# UNITED STATES PATENT AND TRADEMARK OFFICE

10/630,307

<b>Office Action Summary</b>	<b>Application No.</b> 10/630,307	<b>Applicant(s)</b> WASDYKE, JOEL M.	
	<b>Examiner</b> Vy Q. Bui	<b>Art Unit</b> 3773

**DETAILED ACTION*****Claim Rejections - 35 USC § 102/103***

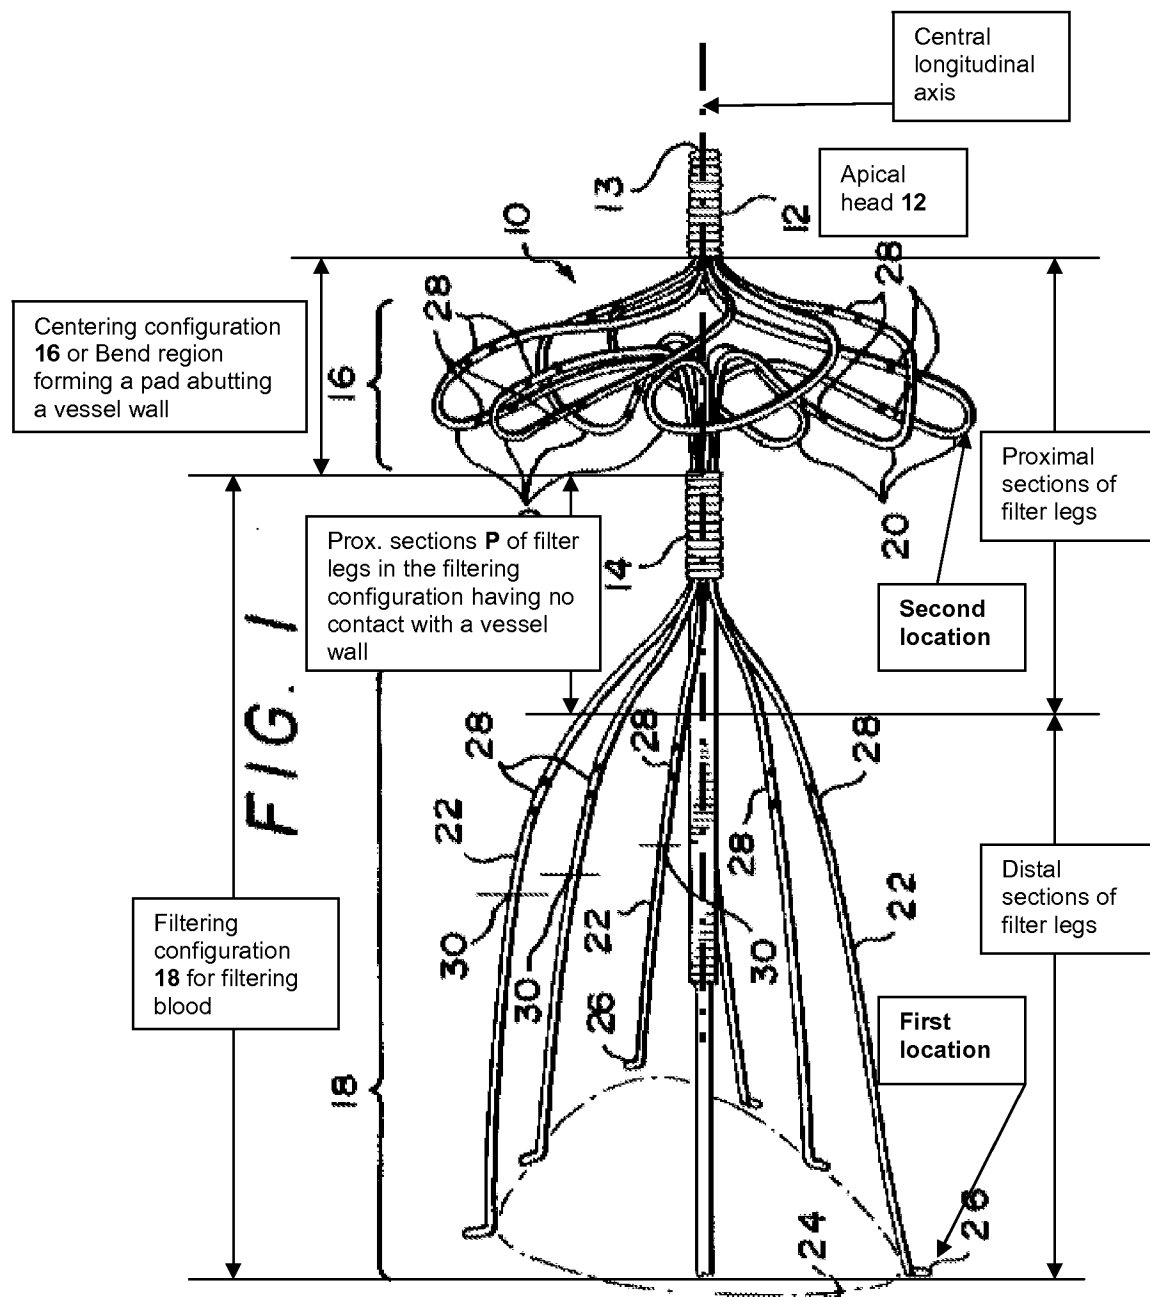
As to claims 13-17, 19-21, 24, 31, 33-34, Kleshinski-'162 (see reproduced and annotated Fig. 1 on next page; C 1, L 24-43; C 3, L 10-22; claims 1-4) discloses filter device 10 implanted in a blood vessel made of a shape memory/ nitinol/ super-elastic material having a transition temperature **about** a body temperature (98.6 F: C 1, L 39-42; claim 4) comprising:

1. apical head 12 having tip 13 and a central longitudinal axis passing tip 13;
2. generally symmetrical filter basket 18 (C 3, L 27-29) in a filter configuration having filter legs 22 with means for attachment/ hooks 26 (Fig. 1) attached to a blood vessel at a 1<sup>st</sup> location for filtering a blood flow;
3. generally symmetrical filter basket 16 (C 3: L 27-44) in a centering configuration having filter legs 20 with bends to form a bend region or a pad to abut the vessel wall (Fig. 1) at a 2<sup>nd</sup> location for filtering a blood flow and for centering the filter device inside the blood vessel.

In a radially collapsed configuration, the filter device is received in a fine plastic tubing or catheter for deployment (C 3, L 10-29) and filter legs 20/22 of the device are straightened and collapsed against one another in the tubing for deployment the filter percutaneously into the blood vessel. The filter device expands inside the blood vessel when the filter is pushed out of the tubing.

Basket 16 and 18 are symmetrical about the central longitudinal axis passing through filter tip 13 (see C 3, L 27-29). Inherently, legs 20/22 are substantially disposed equidistantly

However, a proximal section of each leg 20/22 clearly show section configured to avoid contact with the vessel wall, for example, please see proximal section **P** of the filter configuration in the above reproduced and annotated F 1.

However, loops 20 extend radially outward from a location near apical head 12 or near the central longitudinal axis, and return back to a location near coil 14 or near the central longitudinal axis. As indicated above, Kleshinski discloses basket 16 is symmetrical, therefore the loops 20 must radially extend equidistantly from the central longitudinal axis as recited in the claims.
